# Memorandum

TO: Queensland Floods Commission of Inquiry  
FROM: Mark Babister  
DATE: 7 October 2011  
SUBJECT: Response to Peer Reviews of WMAwater's *Brisbane River 2011 Flood Event - Flood Frequency Analysis* (Sept 2011)  
PROJECT NUMBER: 111024

FIGURE 10  
 FLOOD FREQUENCY ANALYSIS  
 PORT OFFICE GAUGE - LP3 - 1841 TO 2011

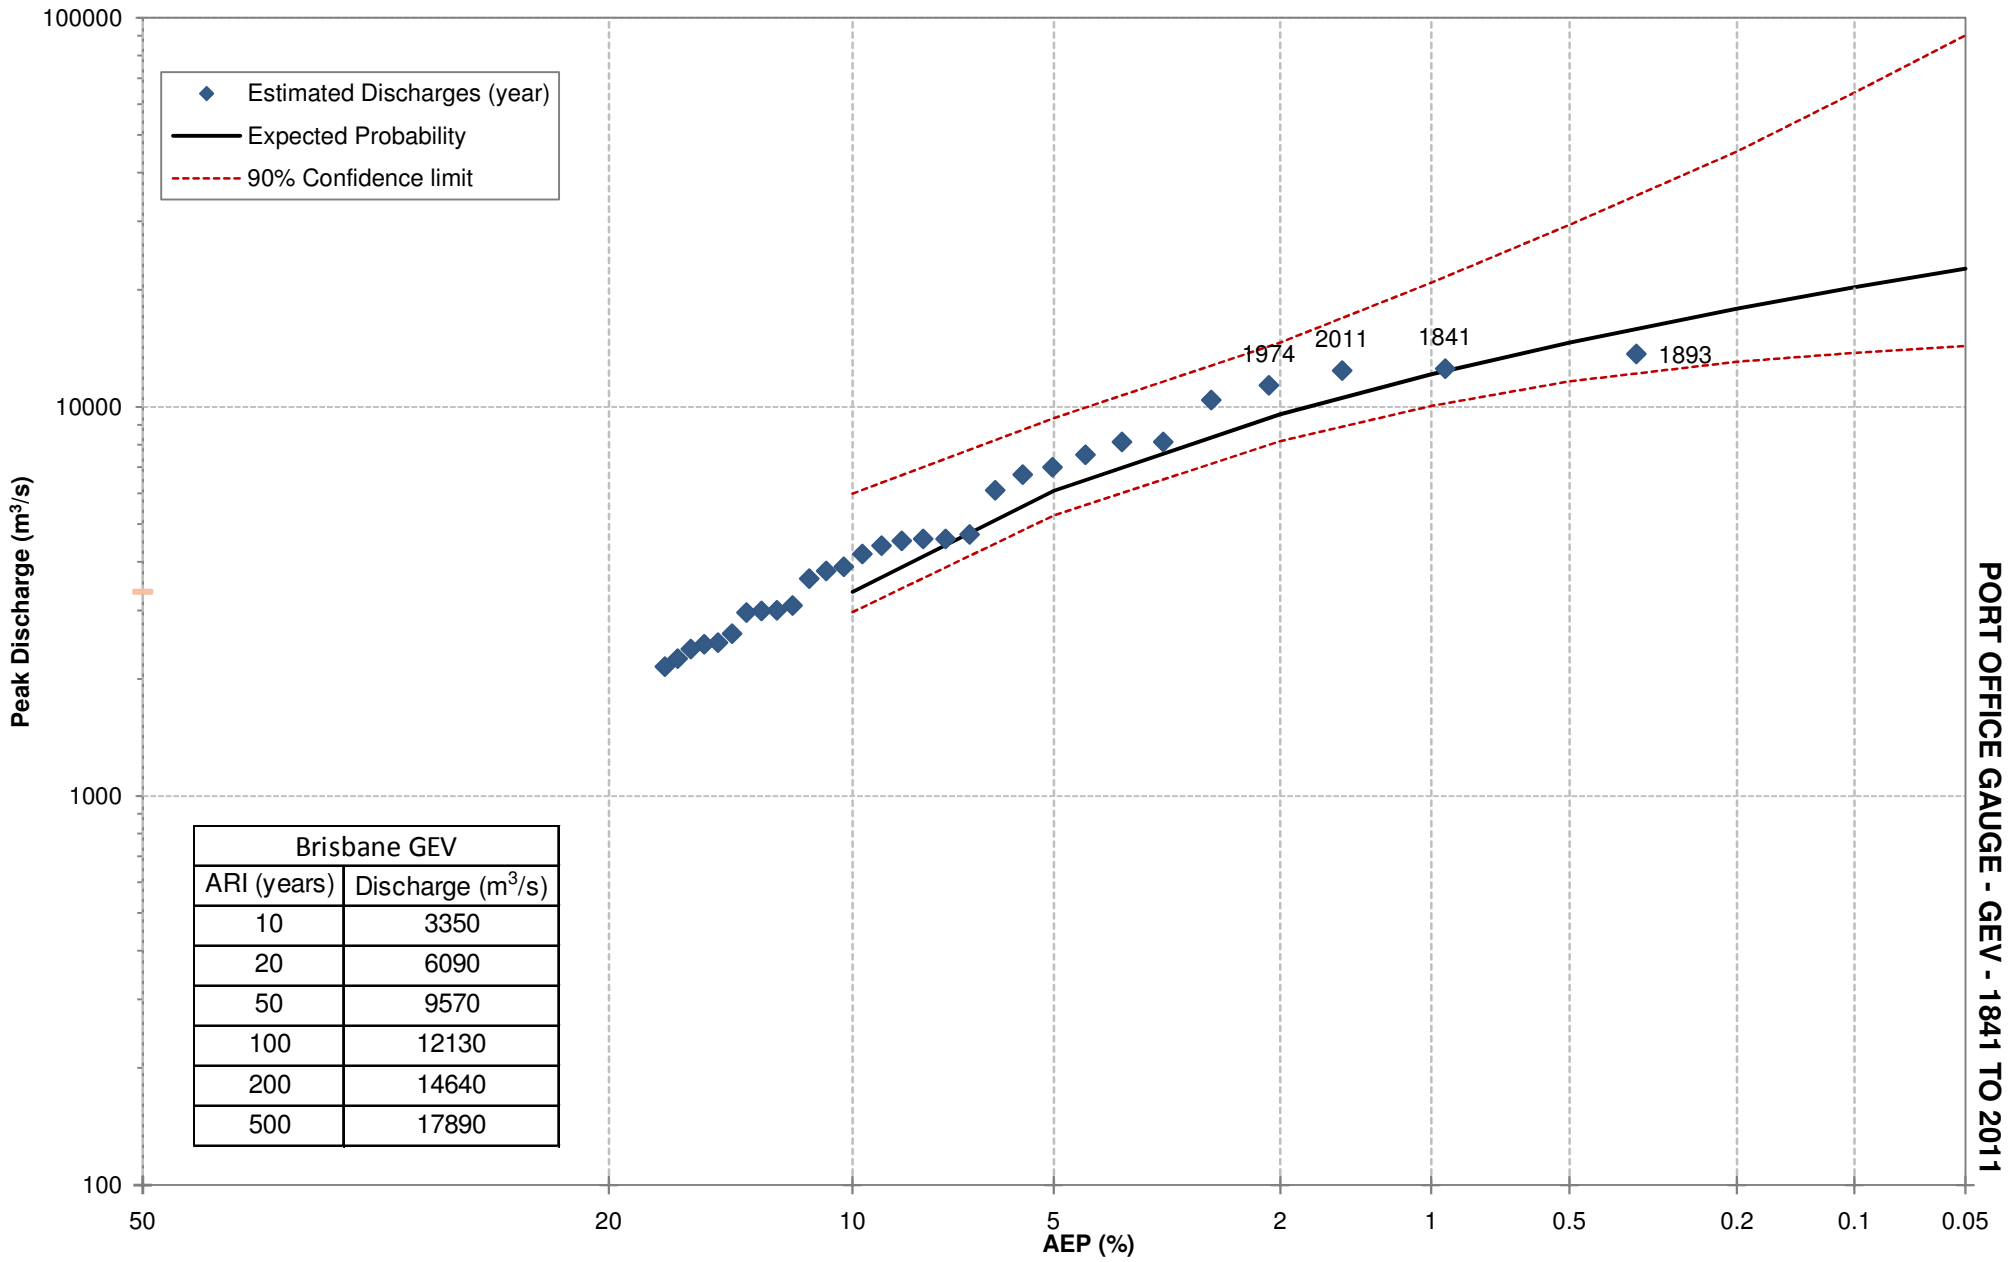
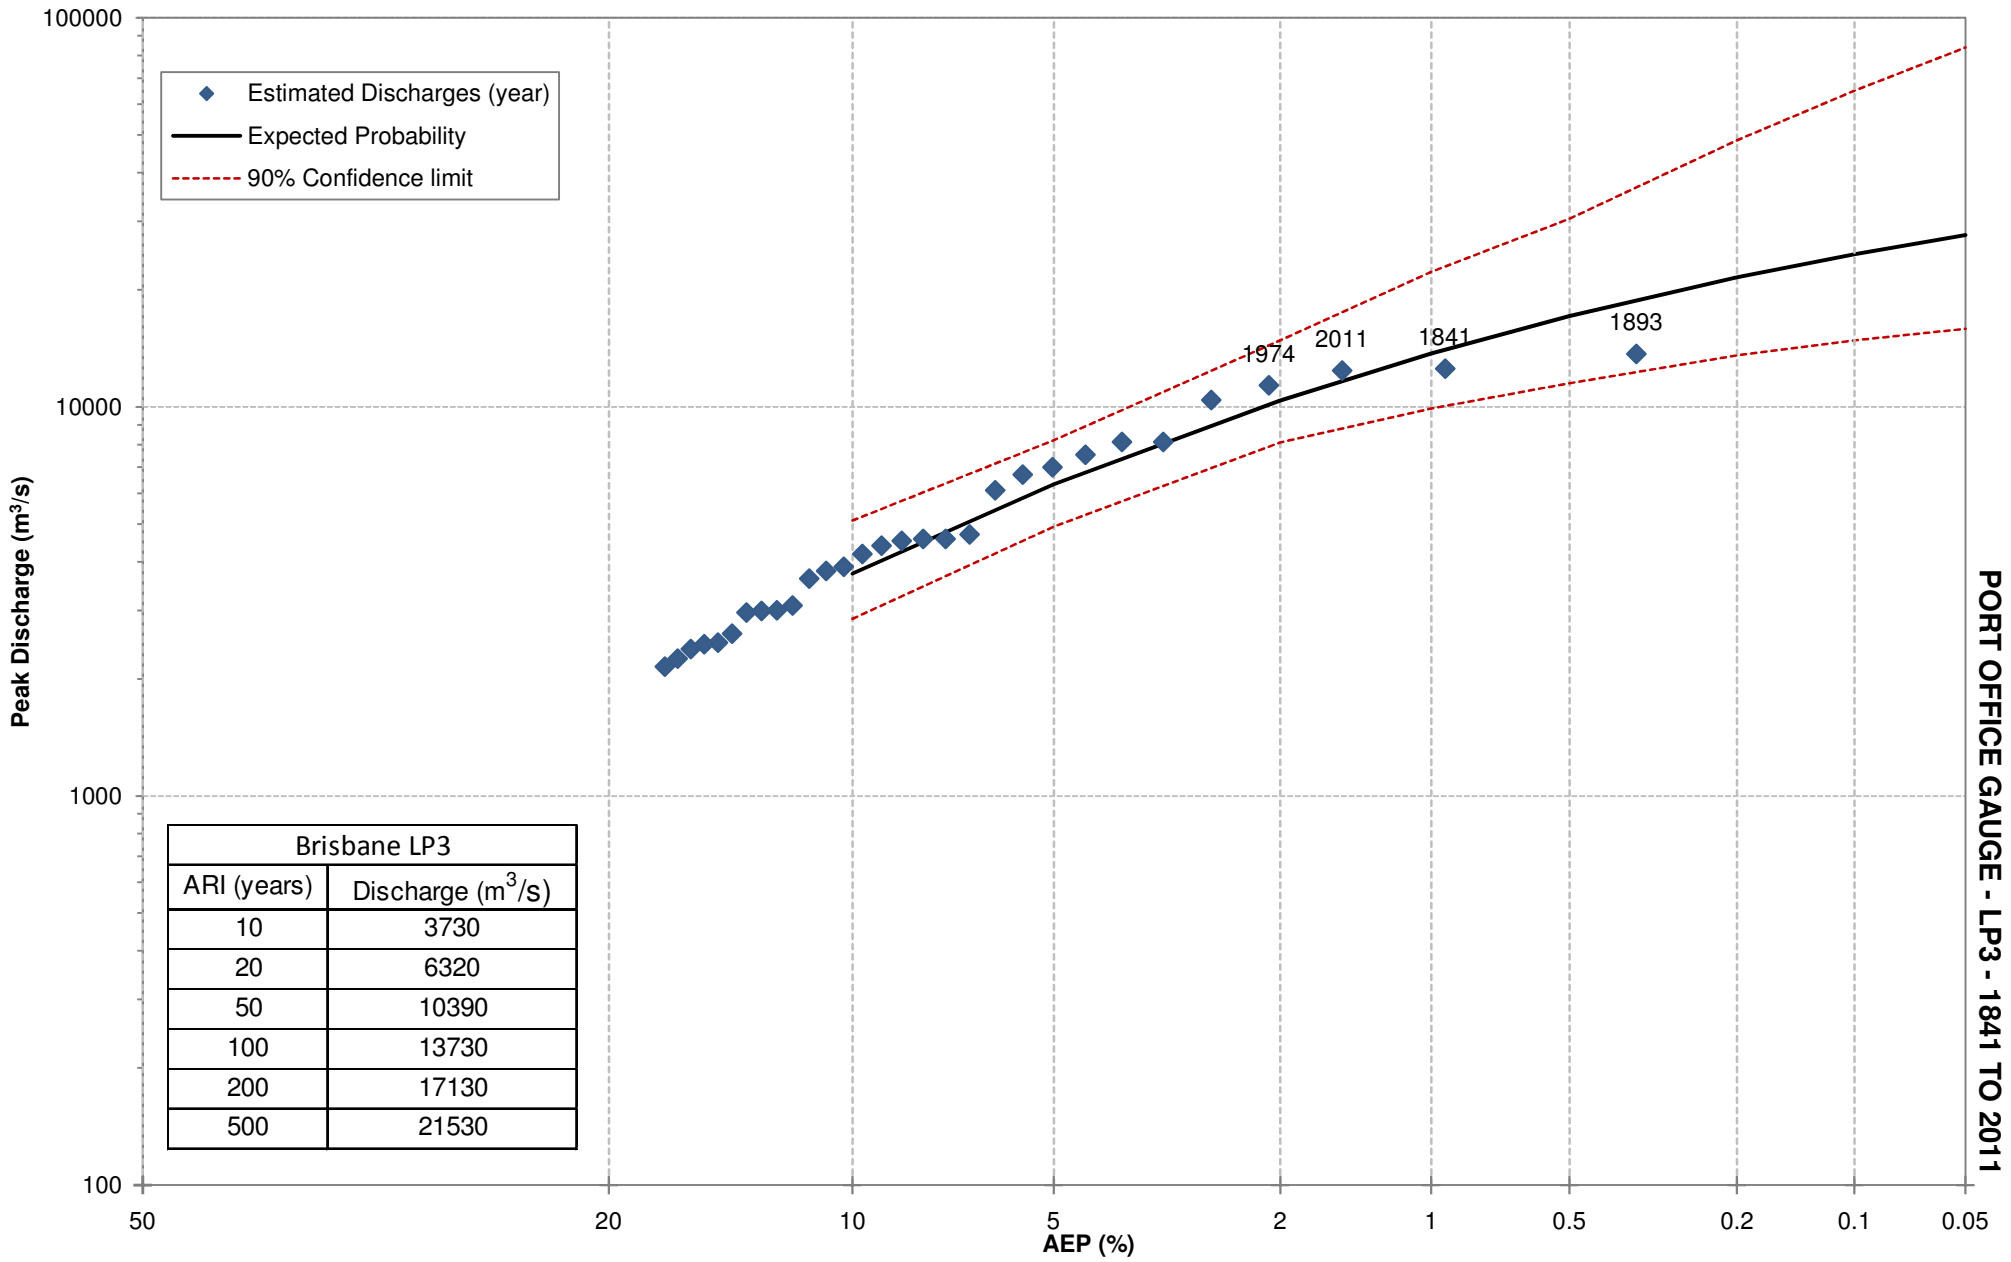
The comparison of the fitted flood frequency curves presented in Figures 9 and 10 indicates that the LP3 distribution (Figure 10) provides a better fit to the flood observations, but fails to reflect the apparent flattening of the flood frequency relationship at peak flows above 10,000 m<sup>3</sup>/s. *The adopted 1% AEP peak flow estimate of 13,000 m<sup>3</sup>/s for the pre-dam conditions appears to be an appropriate 'best estimate', given the flood data series used as basic input.*

The confidence limits shown in Figure 10 of WMA (2011) reflect the uncertainty introduced into the flood estimates because of the high degree of natural variability in the flood data (including random errors) and the limited flood record length available for the estimation of the 3 parameters of the selected distribution. The effects of any systematic under- or over-estimation of peak flows for individual flood events (e.g. resulting from errors in adjusted flood heights or rating curve errors) are not included in these fitted confidence limits, nor do they make allowance for uncertainty in selecting the most appropriate theoretical probability distribution (GEV, LP3 or other candidate distribution).

*Figure 10 indicates a 90% chance that the true 1% AEP flood peak estimate for pre-dam conditions is between about 10,000 and 22,000 m<sup>3</sup>/s but this confidence interval would be wider if allowance was made for other uncertainty factors. In other words, even when the flood data from the largest flood events in a period of record of 170 years at the Port Office are analysed, there remains a substantial degree of uncertainty in the 'best estimate' of the 1% AEP flood peak under pre-dam conditions.*

Inspecting Figure 9 and Figure 10 of the WMA report it seems that the upper uncertainty bound extends to the vicinity of 20,000 m<sup>3</sup>s<sup>-1</sup>, which seems high. The GEV distribution has the following distribution function

FIGURE 13  
**Q100 LINE & JANUARY 2011 PEAK LEVEL PROFILE VS OBSERVED 2011 FLOOD LEVELS  
 (2011 REVIEW PANEL)**

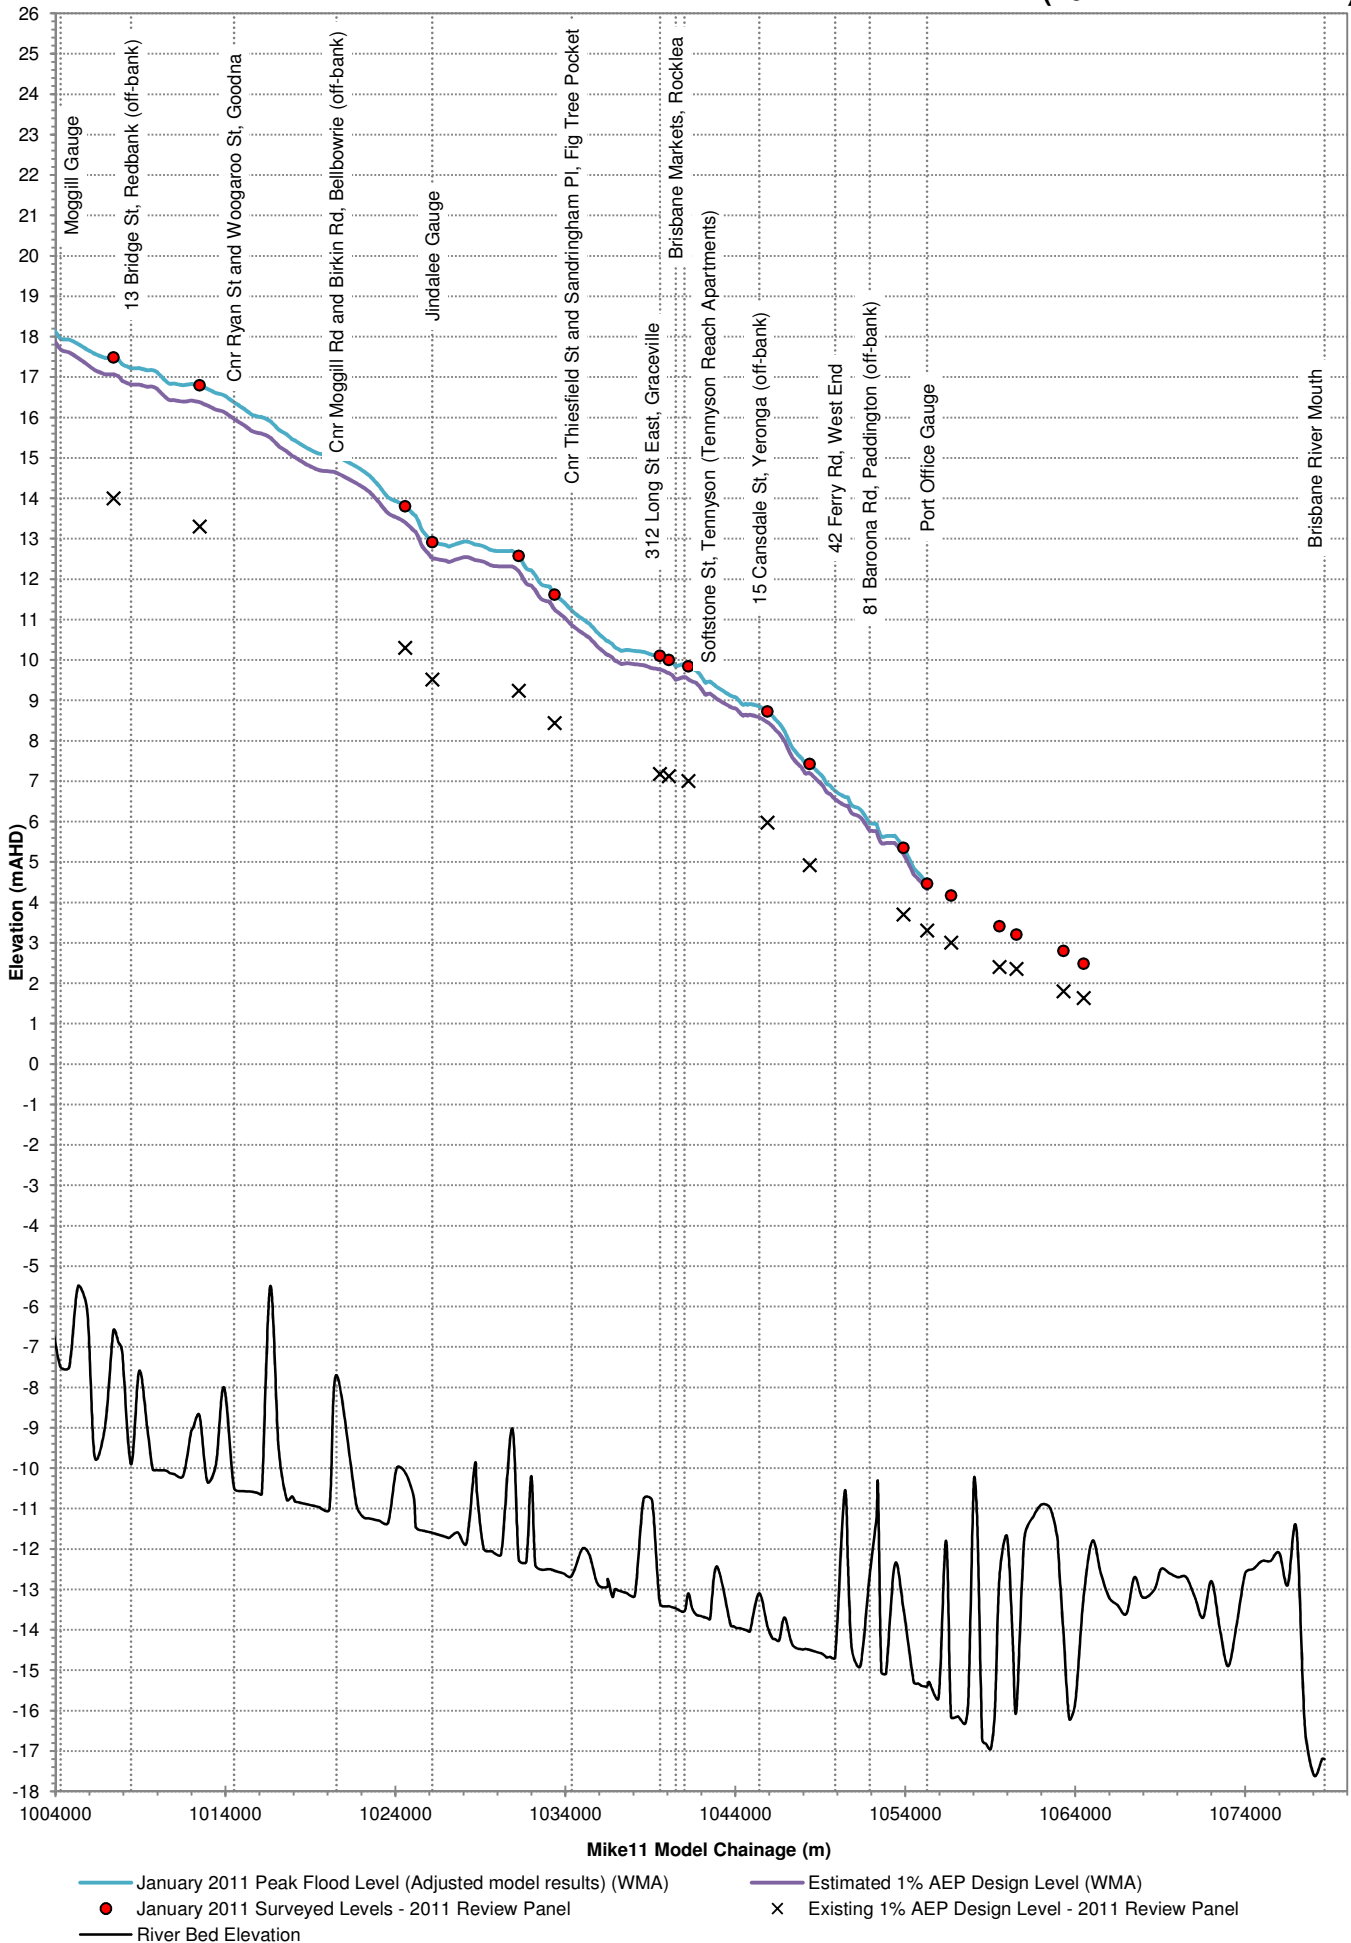
- e. It is not clear how the level of 4.32 m AHD was arrived at. No detail is given on how the MIKE 11 model results were “adjusted”. The resulting profile in Figure 13 looks less plausible than the ‘non-conforming’ one produced by MIKE 11 without adjustment (see Figure 12). The profile in Figure 13 has been made to conform to figures for peak flood levels given in the Joint Flood Taskforce Report (Reference 27). However, it was stated clearly in that report that the levels were “subject to final verification”. When the JFTF report was being produced, the author and another member of the Taskforce shared concerns they had about the accuracy of the flood levels given in Reference 27 for the stretch of the river from the West End Ferry to Seventeen Mile Rocks, because they seemed inconsistent with the rest of the flood profile. At the time, this was the only information available to the Taskforce and it was not feasible to have it checked during the three weeks between the first meeting of the Taskforce and the deadline for completion of the Report (8<sup>th</sup> March 2011). Floodwise Property Reports for the locations of these flood levels, downloaded in September 2011 from the BCC website, indicate that the current best estimates of many of these levels are lower than those given in Reference 27.

**Comment** A note at Table 3 of Reference 27 states explicitly that the Jan 2011 levels given are “subject to final verification”. The resulting profile in Figure 13 looks less plausible than the ‘non-conforming’ one produced by MIKE 11 without adjustment (see Figure 12). The profile in Figure 13 has been made to conform to figures for peak flood levels given in the Joint Flood Taskforce Report (Ref 27). Floodwise Property Reports for the locations of these flood levels, downloaded in September 2011 from the BCC website, indicate that the current best estimates of many of these levels are lower than those given in Reference 27.

It appears that there is an inconsistency in the predicted 100 year ARI flood profile. The adopted peak discharge for the January 2011 flood and the 100 year ARI flood (9,500 m<sup>3</sup>/s) are identical. However, there is a significant difference in the predicted flood profiles for these two floods (see Figure 13 of the WMAwater report). The reason for this difference is not known and has not been explained in the WMAwater report.

The WMAwater report does not provide any details on the inflow boundary conditions (discharge hydrographs) or the downstream boundary condition (tide level) adopted to predict the 100 year ARI flood profile. Based on Figure 13 of the WMAwater report, it appears that the same downstream boundary condition has been adopted for both January 2011 and 100 year ARI Mike-11 model runs. If this is the case, the adopted downstream boundary condition may not be appropriate to predict the 100 year ARI flood profile.
